ROADWAY CONDUIT PLAN

ROADWAY AND GIRDER LEVEL WESTBOUND
(LIGHTING AND ELECTRICAL SYSTEMS)
SCALE: 1:200

E-11

"CCO ____ DRAFT"
08/25/2010

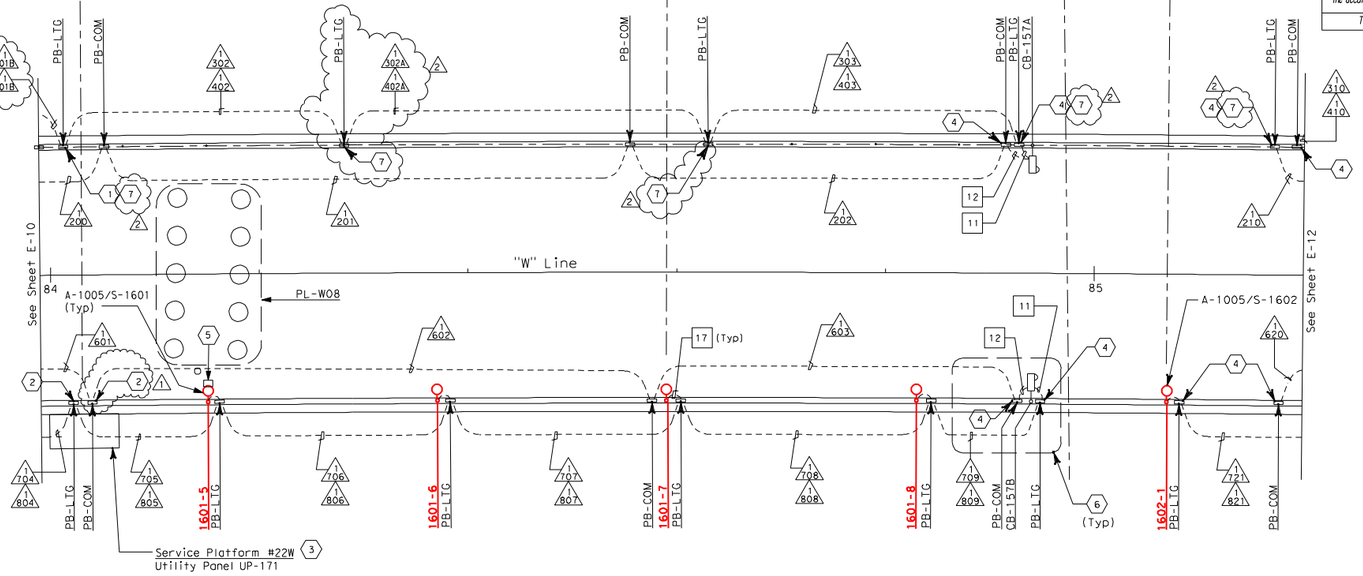
MARK	DATE	DESCRIPTIONS	REV	CK	CCO NO.
2	8/29/08	Added conduit nos 1301B, 1302A, 1401B, 1402A, PB-LTG, sheet notes 7. Re-routed conduits 1301, 1401, 1302 and 1402.	EJL	ECR	Light Pipe
1	8/29/08	Added 2-41C, 4403A & 4404A from PB-Com to Girder Level	EJL	ECR	Light Pole Base
